802.3dj D3.2

Comment Resolution

Logic Topics

PCS stateless decoder

Figure 119-15—Receive state diagram

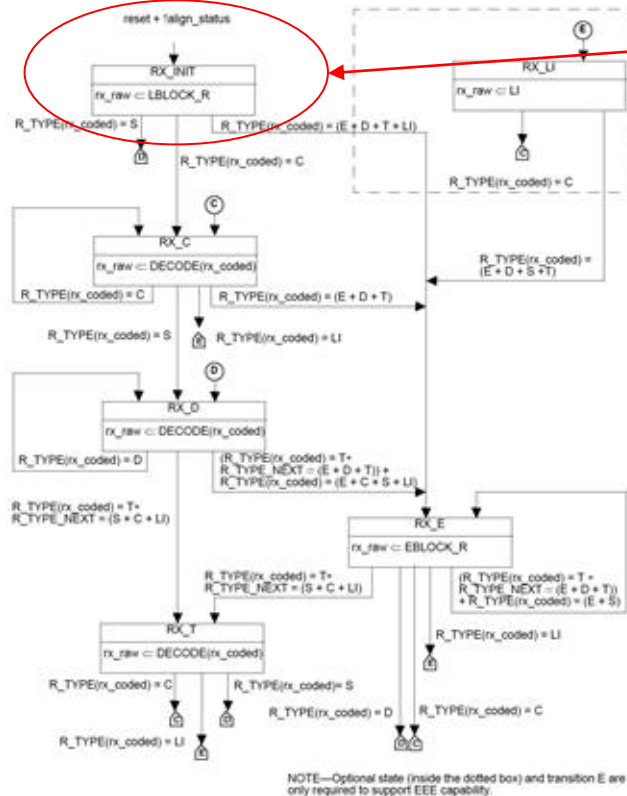
It makes sense that if the PCS has lost alignment marker lock it will generate local faults, as in the case of the state-diagram decoder (see align_status in Figure 119-15).

State diagram decoder:

LBLOCK_R (Local Fault) is used when: (reset or !align_status).

Other states use “DECODE” function or substitute EBLOCK_R for an invalid sequence.

From 119.2.5.8.2:

“The stateless decoder generates 200GMII/400GMII transfers based only on the current 66-bit block and PCS reset. When PCS reset is asserted, $RXD<63:0>$ and $RXC<7:0>$ are set to the constant **LBLOCK_R**”

→ Need to add the !align_status condition to also generate Local Fault (LBLOCK_R) to match the state diagram. This is the standard behavior when the PCS cannot decode the incoming signal. (Note: stateless decoder does not check for invalid sequences).

Change the text in 119.2.5.8.2

from:

"The stateless decoder generates 200GMII/400GMII transfers based only on the current 66-bit block and PCS reset. When PCS reset is asserted, RXD<63:0> and RXC<7:0> are set to the constant LBLOCK_R (see 119.2.6.2.1). When PCS reset is not asserted, RXD<63:0> and RXC<7:0> are decoded from rx_coded<65:0> as defined in 119.2.3." to:

"The stateless decoder generates 200GMII/400GMII transfers based only on the current 66-bit block and the PCS variables align_status and reset (see 119.2.6.2.2). When reset is true or align_status is false, RXD<63:0> and RXC<7:0> are set to the constant LBLOCK_R (see 119.2.6.2.1); otherwise, RXD<63:0> and RXC<7:0> are decoded from rx_coded<65:0> as defined in 119.2.3."
